STAFF RECOMMENDATION
1308 6th Avenue North
June 18, 2014

Application: New construction - addition
District: Germantown Historic Preservation Zoning Overlay
Council District: 19
Map and Parcel Number: 08209005900
Applicant: Sonya Link, Owner
Project Lead: Sean Alexander, sean.alexander@nashville.gov

ROOF PLAN

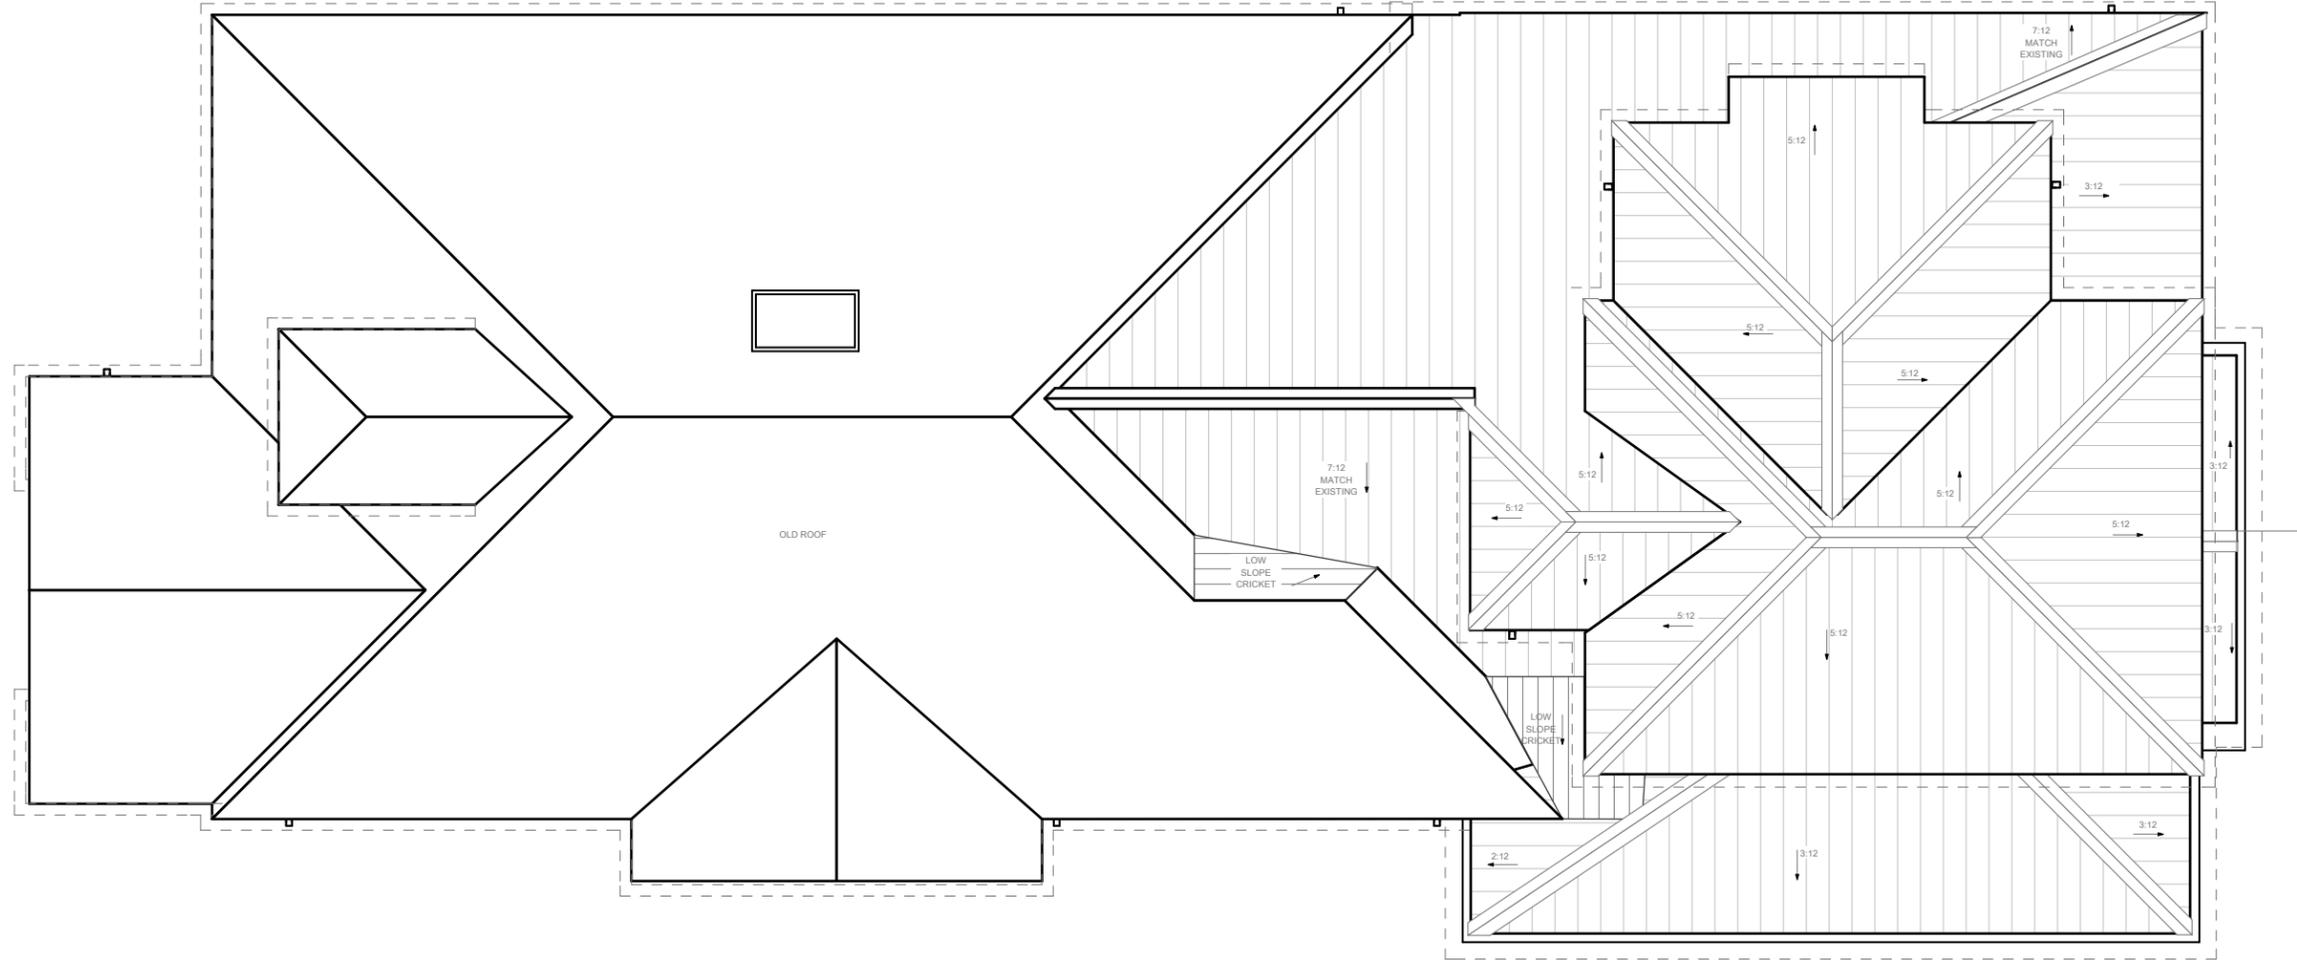
The primary roof of the addition will tie into the rear slope of the existing hipped roof one foot (1') below the existing ridge, continuing back with a hipped roof matching the original roof pitch. The upperstory will rise from within the addition's hipped roof at the rear in a manner similar to an "aeroplane dormer." The upperstory roof will be only be three feet, five inches (3'-5") taller than the ridge of the historic roof at the peak, but will have a lower pitch causing the eaves to be eight feet (8') higher than the eave line of the historic house.

FRONT ELEVATION

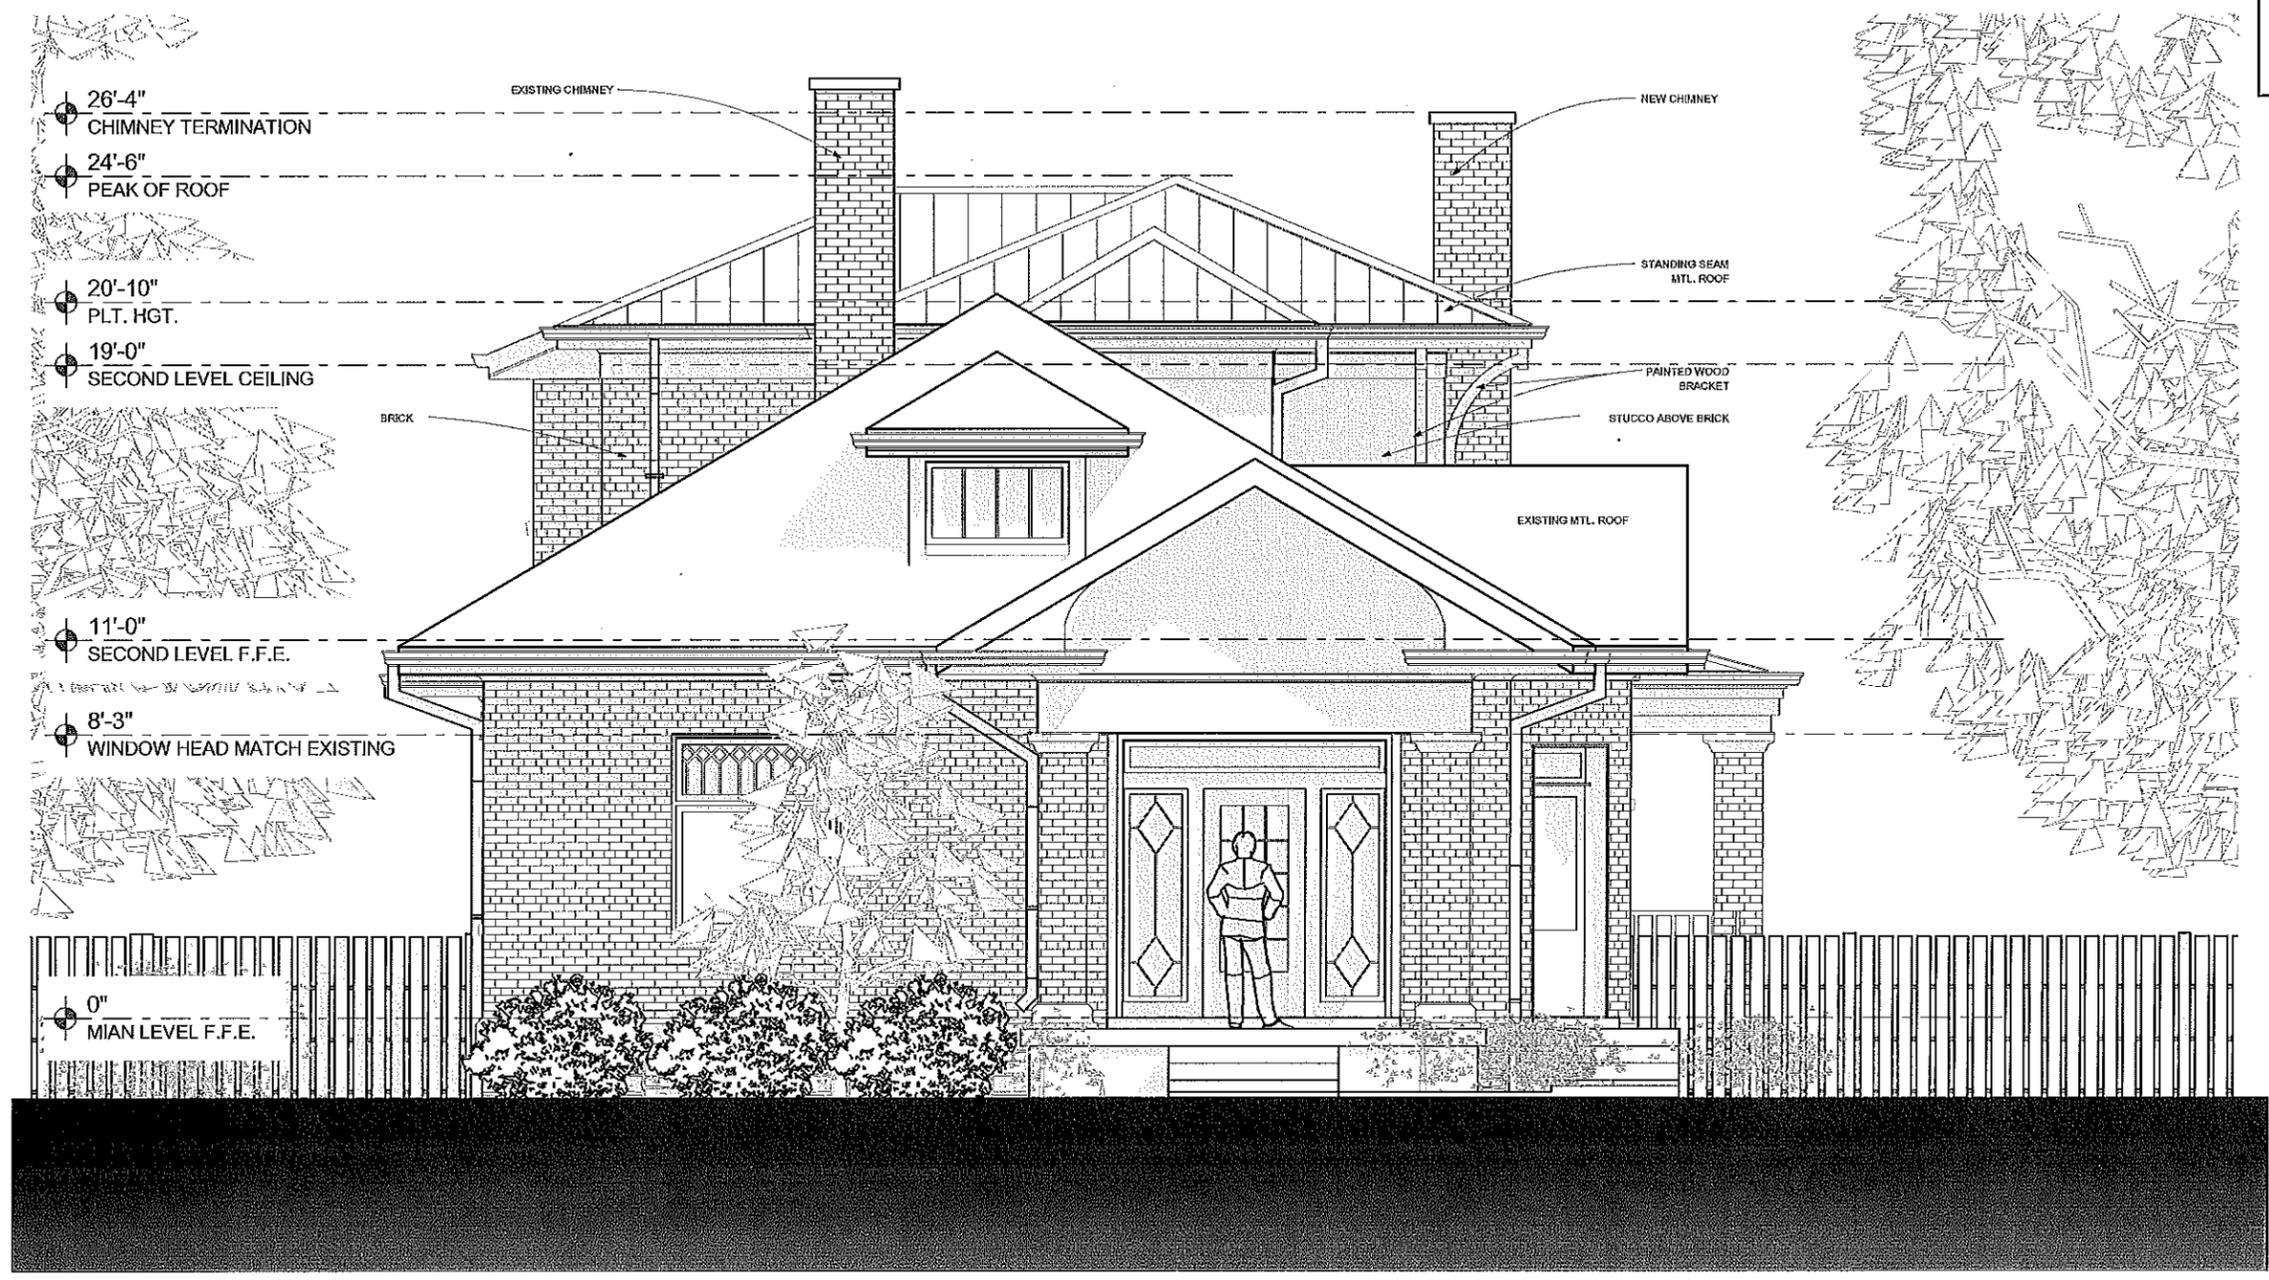
The addition has a second story component, that although set back, is highly visible. In the past, the commission has only allowed for taller additions that have minimal increases in height and where the only portion of the addition that could be seen was primarily roof. In this case, a good deal of wall will also be seen.

Whereas the upperstory form might be entirely obscured behind a side-gabled roof, it will be very visible because of the original hipped roof, and would contrast with the historic form. Staff finds that the upperstory addition would not be subordinate to or compatible with the historic structure, and would not meet guidelines 2.2.3, 4.2.2 and 4.2.5.

With a condition that the height and massing of the upperstory be significantly reduced or eliminated, Staff finds that the width and massing of the addition would otherwise meet guidelines, 2.1.4, 2.2.3, 4.2.2 and 4.2.5.

1. That the height and massing of the upperstory be significantly reduced or eliminated;
2. Staff shall approve the windows and doors as well as roof color and masonry samples;
3. Repairs or alterations to the existing structure, including roofs and windows, shall be reviewed by Staff; and,
4. Changes to the site appurtenances and utilities are reviewed by Staff.

RIGHT ELEVATION

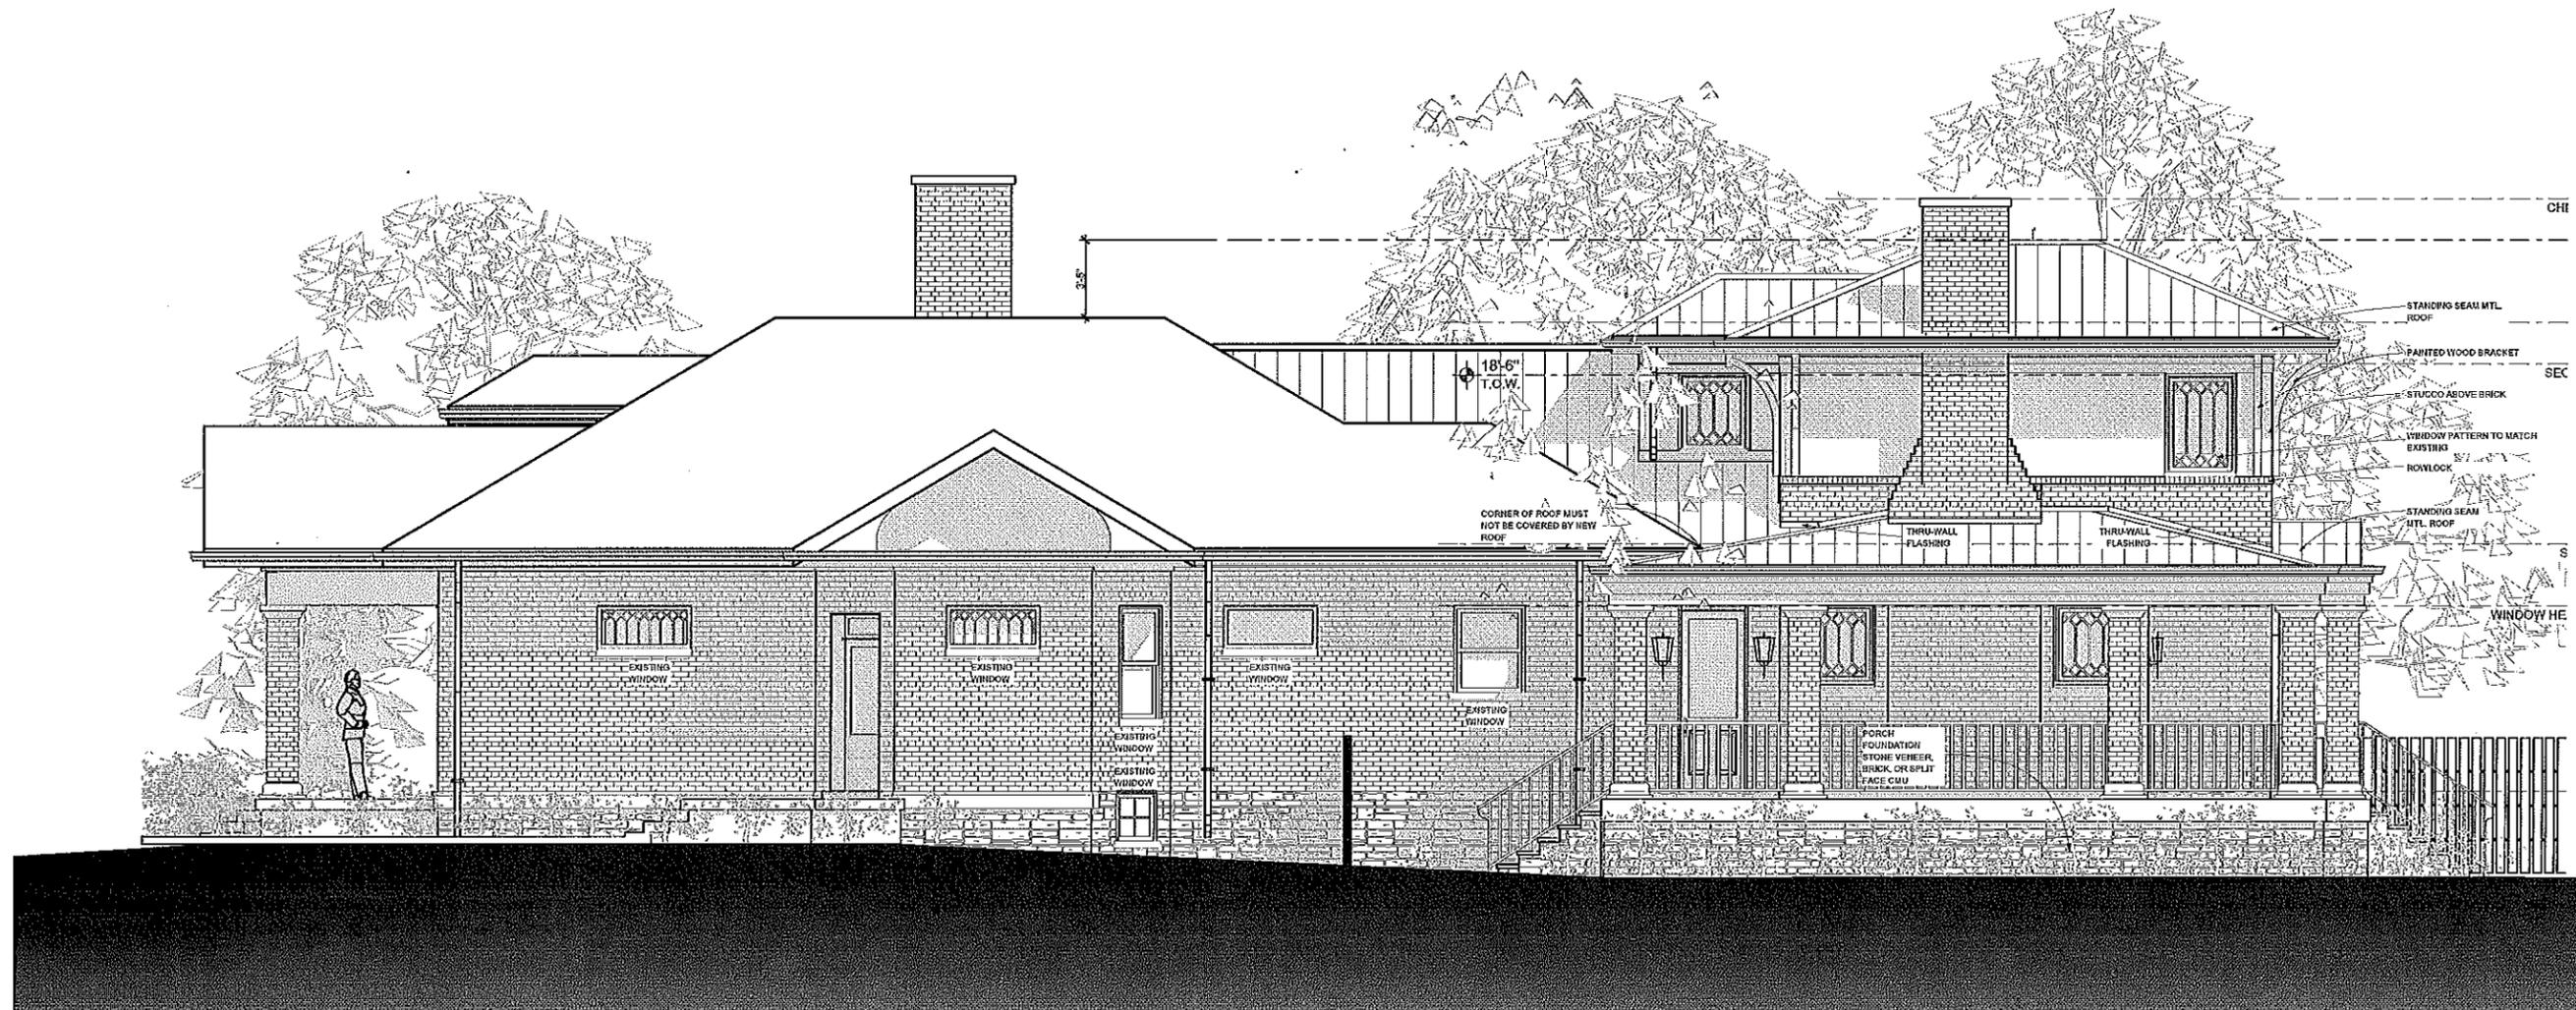
On the first story, the addition will sit in from the sides of the existing structure with a two-foot (2') deep alcove before stepping back out to match the primary width of the historic building. An eight-foot (8') wide porch will expand the width to the right, but will be partially obscured by an existing projecting bay on the house. Staff finds the additional width to be appropriate because of the bay, and because of the open nature of the porch. By setting in from the sides of the house, the addition will not obscure or harm historic features of the front or sides of the house, thereby meeting guidelines 4.2.1 and 4.2.3.

In the upperstory, the sides of the addition will be set in from the primary walls of the first story by two feet (2') on the right and by three feet, six inches (3'-6") on the left, with a portion of the left wall then stepping out an additional eighteen inches (18").

On the right side of the house, the primary wall of the existing house is sixteen feet (16') from the property line with a projecting bay expanding the width by four feet (4'). The addition will match the width of the existing house on the right, with the open porch extending four feet wider than an existing bay with a setback of eight feet (8'). The addition would match the existing four foot, three inch (4'-3") setback on left side setback. These setbacks are compatible with the rhythm of spacing found among the historic context, and meet the bulk setback requirements of the MUN base zoning. Staff finds the proposal to meet guideline 2.2.1.
